Subject: RATTLE NOISE FROM REAR STABILIZER	Bulletin No: 02-005/12
	Last Issued: 10/18/2012

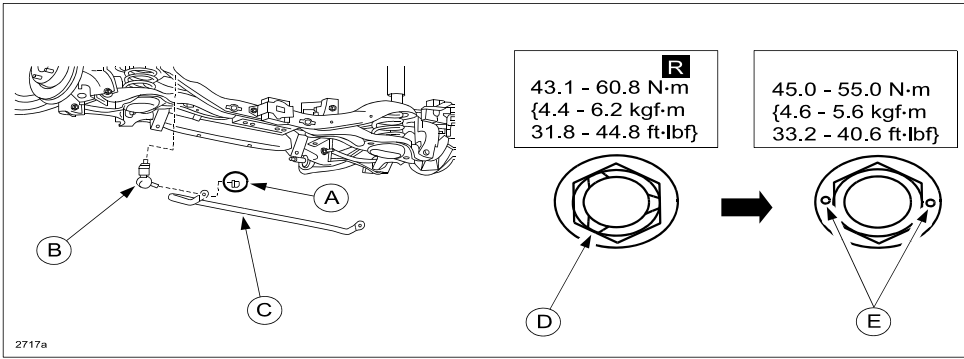
Some vehicles may exhibit a rattle type noise coming from the rear stabilizer when driving over a road bump. This noise may be caused by a loose rear stabilizer control link.

1. Verify customer concern.
2. Verify the rear stabilizer control link nut torque is below the 31.8 - 44.8 ft-lbf specification.
3. If loose, replace with new nuts (A). Refer to MS3 online or Workshop Manual (section 02-14 REAR STABILIZER REMOVAL/INSTALLATION).

NOTE: After removing the nuts, inspect the threads of the bolts. If wear exists, replace the control link.

Old Style Locking Nut	New Style Locking Nut
		<div> <div> R 43.1 - 60.8 N·m {4.4 - 6.2 kgf·m 31.8 - 44.8 ft·lbf} </div> <div>  </div> </div>	<div> <div> 45.0 - 55.0 N·m {4.6 - 5.6 kgf·m 33.2 - 40.6 ft·lbf} </div> <div>  </div> </div>
Item	Description		
A	Locking Nut		
B	Rear Stabilizer Control Link		
C	Rear Stabilizer		
D	Old Style Locking Nut		
E	New Style Locking Nut With Identification Marks
